G-2	G-1	ITEM	DRAWING NO.	DESCRIPTION	PROJECT NO.	USED ON ASS'Y
QUANTITY		NO.				
TOLERANCES UNLESS OTHERWISE SPECIFIED			APPROVED	DATE	FINISH & SPECIFICATION	
DECIMAL		± .005	<i>[Signature]</i>	12-28-59	MATERIAL & SPECIFICATION	
FRACTIONAL		± 1/64"			TITLE	
ANGULAR		± 1/2°			STORAGE RACKS FOR FINISHED PINS	
BREAK ALL SHARP EDGES REMOVE ALL BURRS			APPROVED	DATE	SCALE	SIZE
			<i>N. Weiss</i>	12-28-59	NONE	C
ENGELHARD INDUSTRIES, INC. D. E. MAKEPEACE DIVISION ATTLEBORO, MASS.					DRAWING NO.	REV.
					50034	A

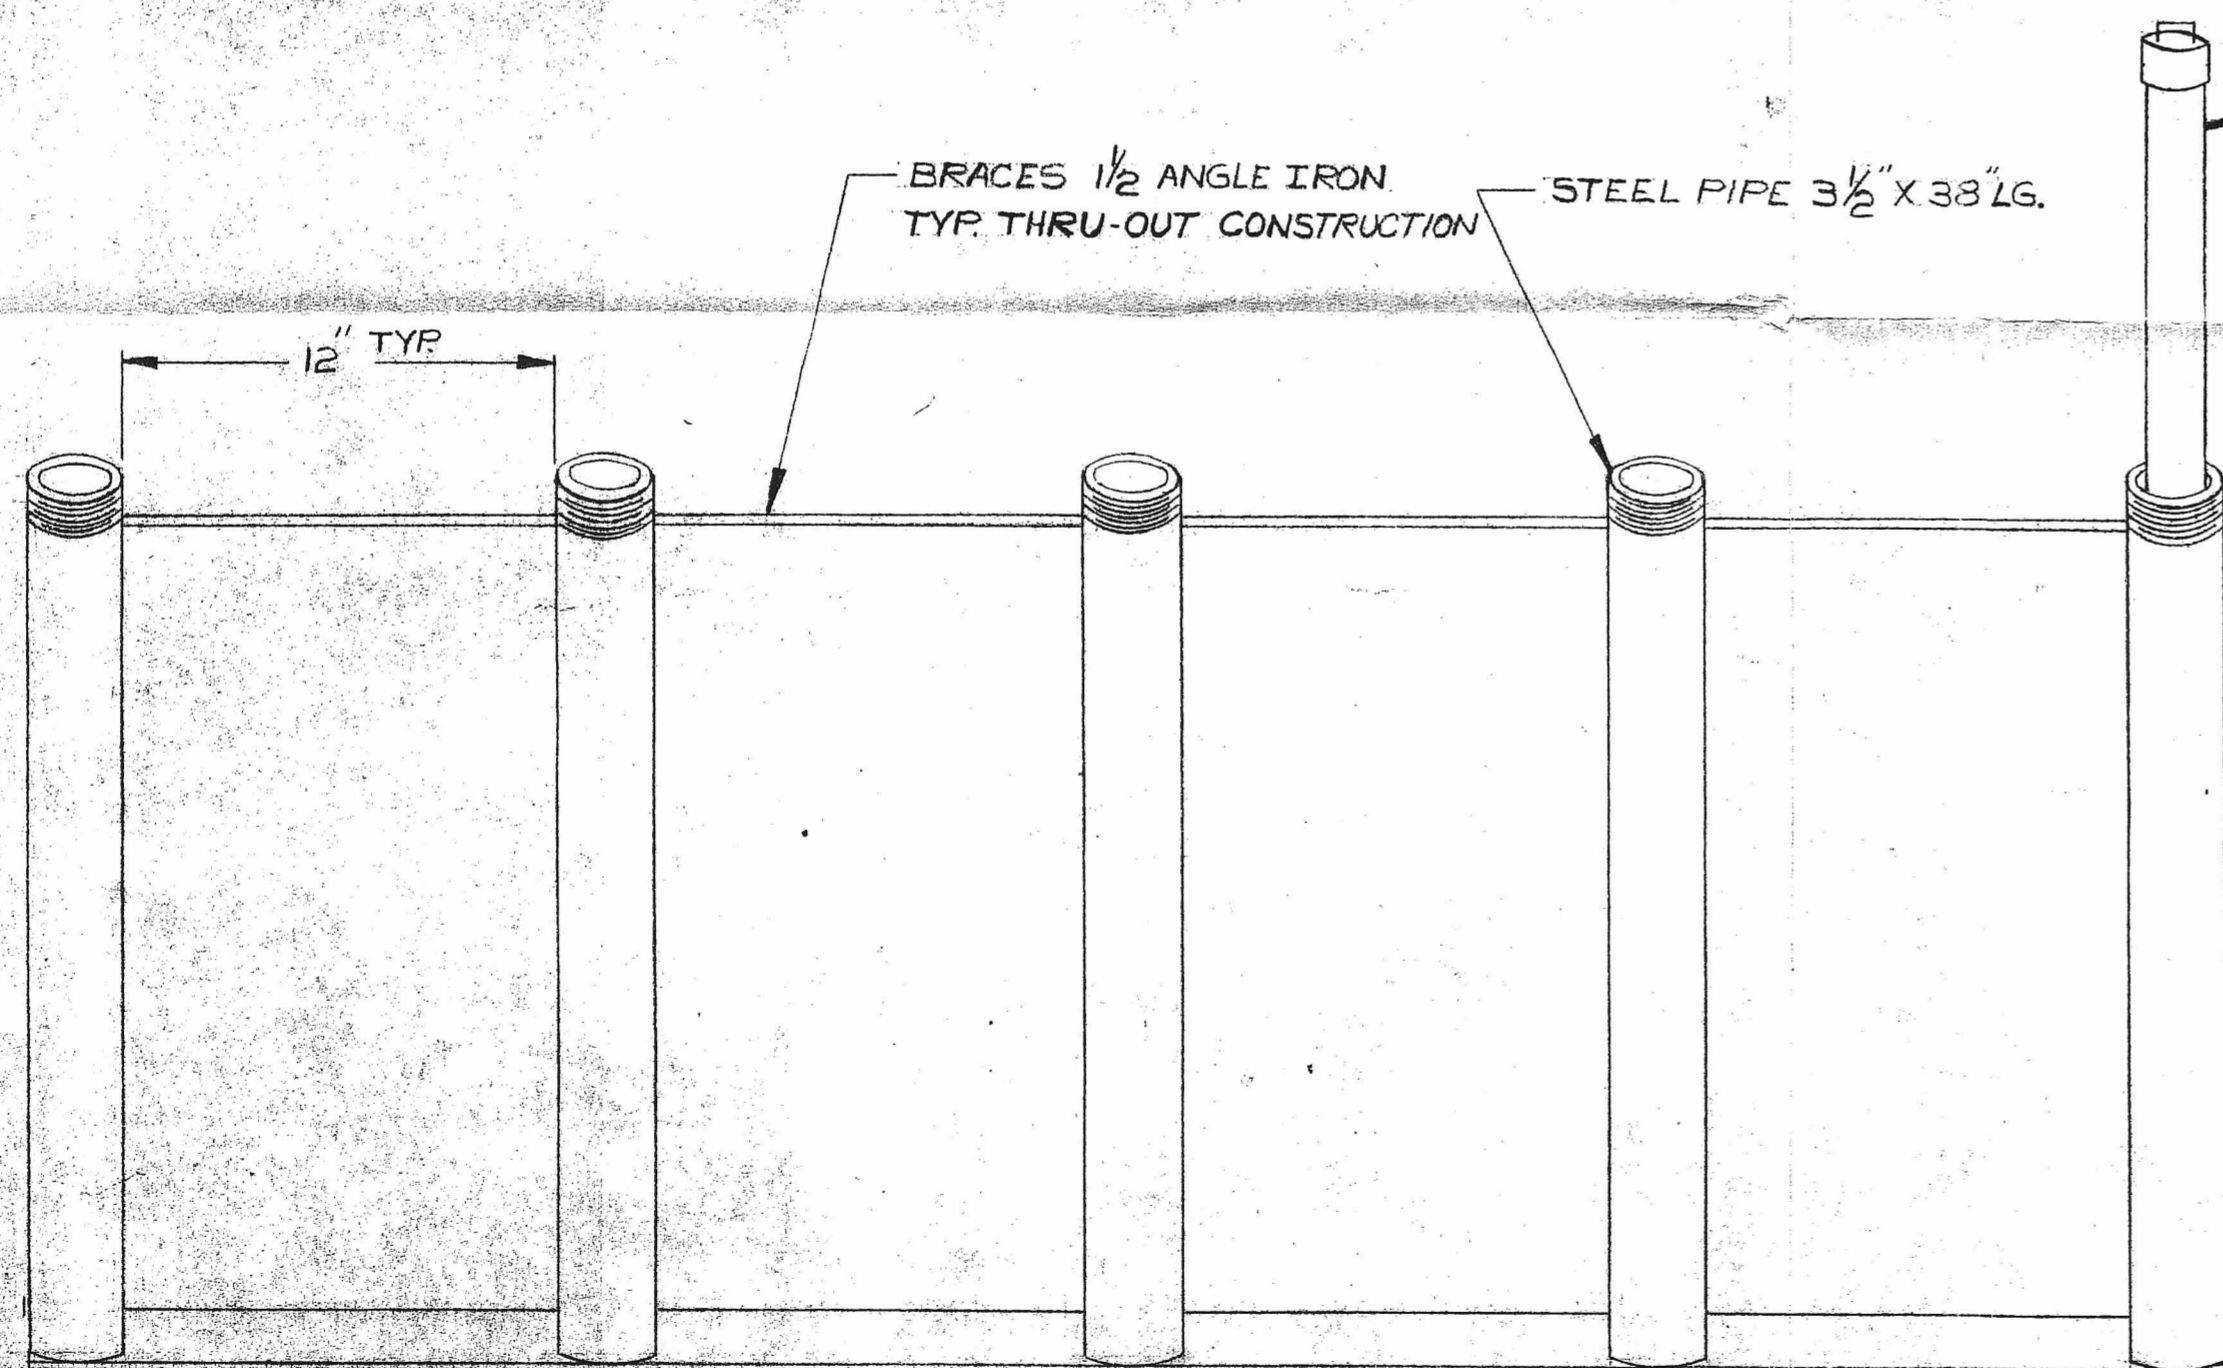
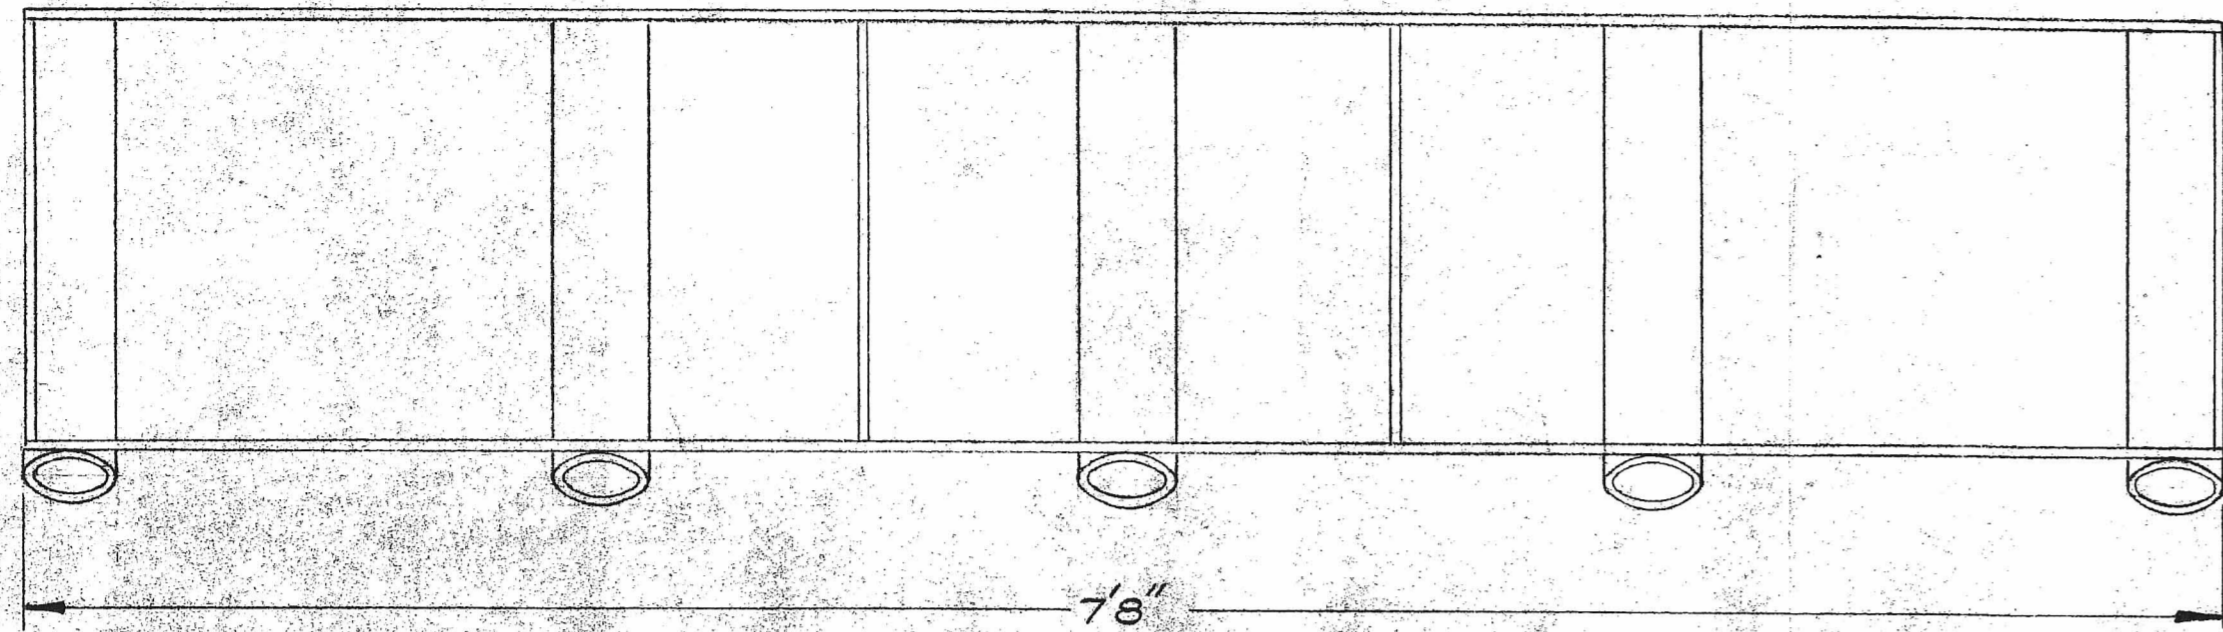
CHG. LET.	DESCRIPTION	DATE	BY	APP.	CHG. NO.
A	REMOVED CADMIUM LINER CHANGE TUBE SPACING TO 12" CHANGE BRACE FOR FLOOR MOUNTING	3/10/60	AJF		147
